2 Model 6922NB

SERVICE CHANGE

1. Change on Gear and Gear Housing.

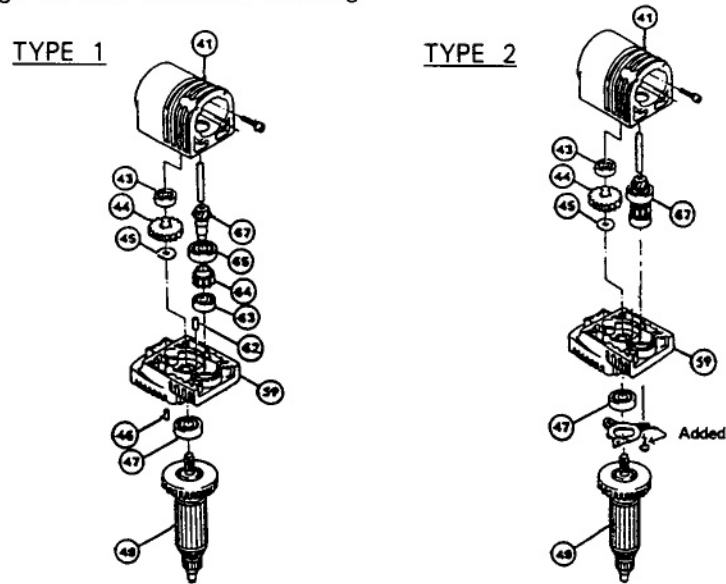
FIG.	DESCRIPTION	TYPE 1	TYPE 2
41	Gear Case Complete	PART# 159677-9 (Discontinued)	PART# 159930-3
43	Ball Bearing	PART# 211033-2 (608LB)	PART# 210013-5 (698VV)
44	Spur Gear 34	PART# 226267-4 (Discontinued)	PART# 226475-7 (Helical Gear 30)
45	Washer 617	PART# 216209-6	PART# 212048-2 (Thrust Needle Bearing)
46, 62	Rubber Pin 4	PART# 263002-9	-----
49	Armature 115V	PART# 517071-5 (with Spur Gear) (Discontinued)	PART# 517191-5 (with Helical Gear)
59	Gear Housing Complete	PART# 159725-4 (Discontinued)	PART# 134788-1 (Incl. Fig. 47. Bearing Retainer, 344470-6 & 3ea. Screw M4x10, 911111-5 are added)
63	Ball Bearing 608LB	PART# 211033-2	PART# 134790-4 Gear Assembly (Helical Gear)
64	Spur Gear 18	PART# 226268-2	
65	Ball Bearing 6000LLB	PART# 211061-7	
67	Spiral Bevel Gear	PART# 226711-1

The above parts are interchangeable as a set.
